Site Review Pre-Application Multi-Family/Attached Single Family Dwellings/Two-Family Dwelling or Commercial Structures and Additions Thereto

Project Name/Description
RIVERSIDE STORAGE

TO: Kandi Talbot, Planner
FROM: Jim Wendel, PE, Development Review Coordinator
DATE: February 22, 1999
RE: Site Plan Review
Riverside Storage
980 Riverside Street

The
 MODIFIED SITE PLAN
 NEW MINI STORAGE BUILDING
 980 RIVERSIDE ST., PORTLAND, ME

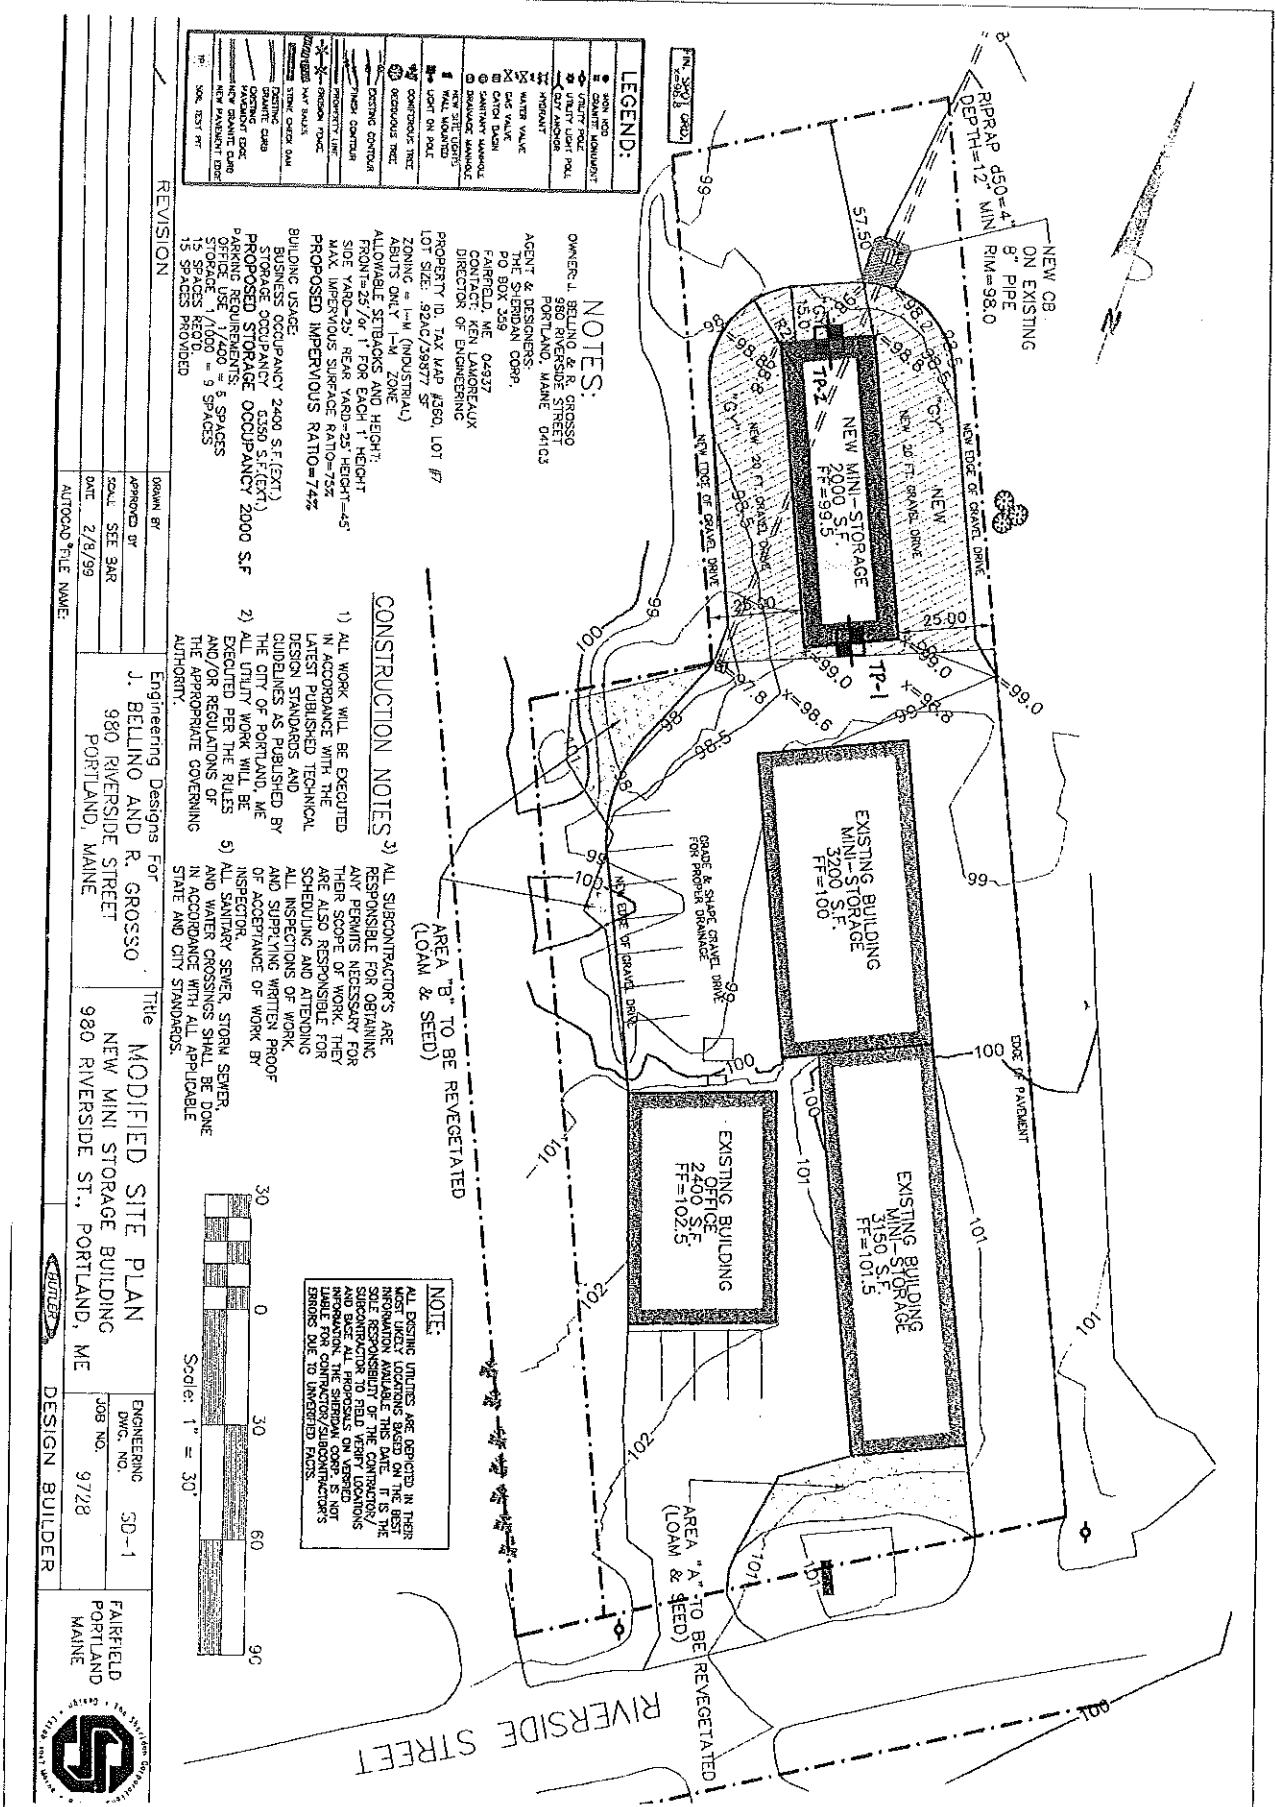
1. We recommend that additional grading detail be provided on the plan; the plan is not fully clear where the runoff is intended to go. Also the existing contour in the northwesterly corner of the gravel surface suggests that ponding will occur and will not enter the storm drain system; this condition should be eliminated.
2. We recommend that some runoff analysis be provided to show that the existing system has the capacity to take the increase. This analysis should include the abutting property that drains into the lower catch basin; the outlet pipe to this system is larger than the pipe on site. The use of the rational method would be appropriate.
3. The plan suggests that the area around the catch basin will be riprapped; there is no detail for it.
